## INSTRUCTION SHEET

## 8235 UPDATE KIT ROTATION BY MOTOR

SA92IA snowblowers with serial # 2028772 to 2028781 and SET11013 to SET11022

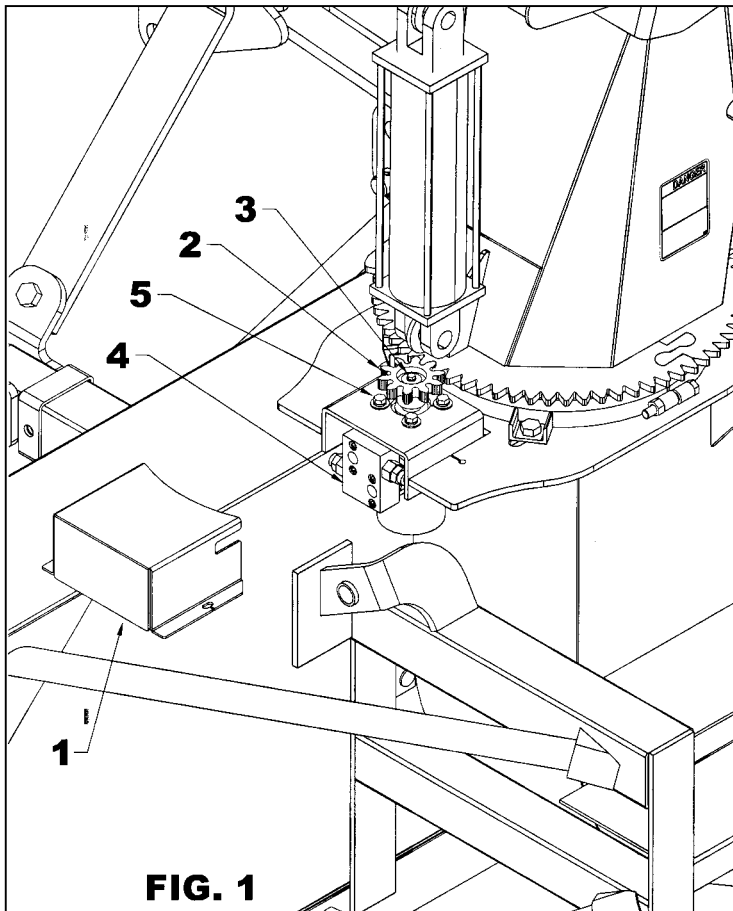
1. **Figure 1:** Remove the cover (item 1). Remove the motor gear (item 2) by unscrewing the bolt (item 3) of the motor (item 4). Keep at hand the motor gear, key, bolt and washers.
2. **Figure 1:** Remove the four bolts (item 5) that fix the motor (item 4).

**FIG. 2**

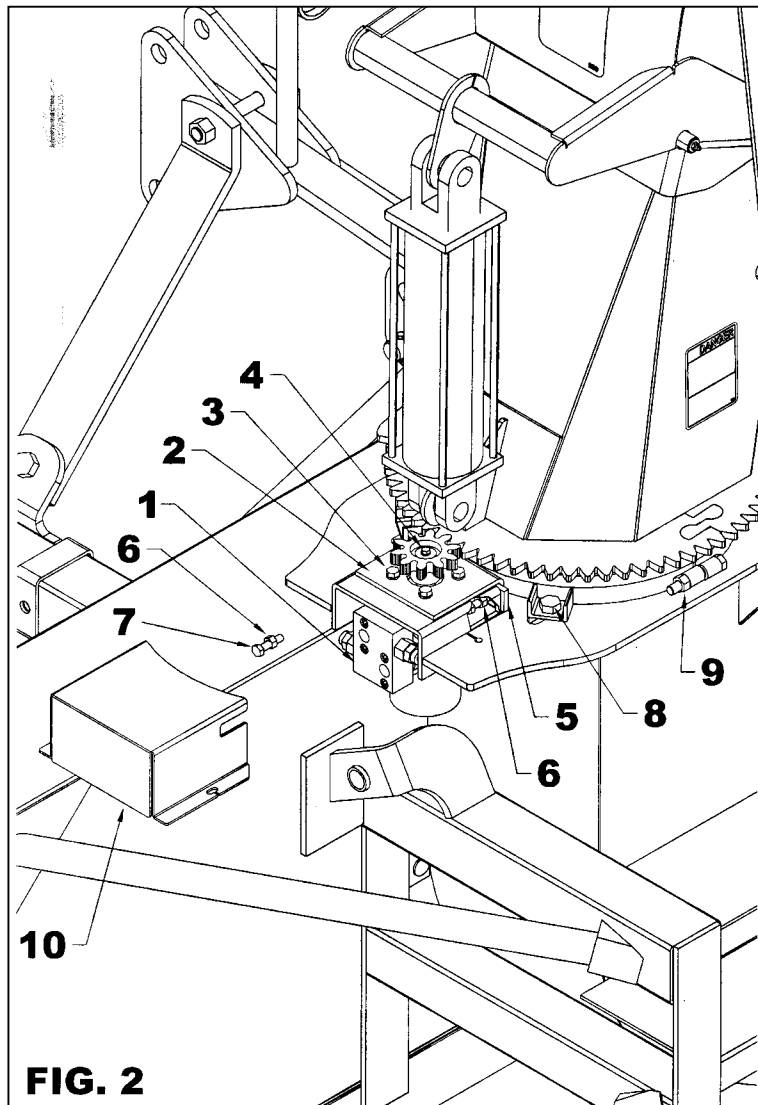
3. **Figure 2:** Reinstall the motor (item 1) placing it above the new anchor plate (item 2) as shown on figure. Attach with four 3/8"NC x 1" lg (item 3) hex. bolts and lockwashers. Tighten manually.
4. **Figure 2:** Reinstall the motor gear with the key, bolt (item 4) and washers previously removed. Tighten according to the Torque Specification Table located at the end of your snowblower manual manual.
5. **Figure 2:** Insert the anchoring flat bar (item 5) between the anchor plate (item 2) and the motor support as shown on figure. Screw the 3/8NC nuts (item 6) at maximum on the two 3/8"NC x 1 1/2" lg bolts (item 7). Install those two bolts (item 7) by screwing them in the anchoring flat bar (item 5).

6. **Figure 2:** Adjust the distance between the chute gear and the motor gear according to the following step:

- A- Slightly unscrew the two bolts (item 8) that hold the retaining plate.
- B- Screw the two nuts (item 9) simultaneously until the distance between the retaining plates and the chute base is leveled.
- C- Retighten the bolts (item 8) according to the Torque Specification Table located at the end of the manual.
- D- Adjust the gears with a distance of  $1/32"$  to  $1/16"$  by screwing the two bolts (item 7). Secure with the nuts (item 6) moving them against the anchoring flat bar (item 5). Tighten the four bolts (item 3) according to the Torque Specification Table located at the end of the manual.
- E- Run a test at low speed. If the gears make irregular sound while testing, it means the adjustment is incorrect. Bring parts closer to each other until the sound becomes regular and even.
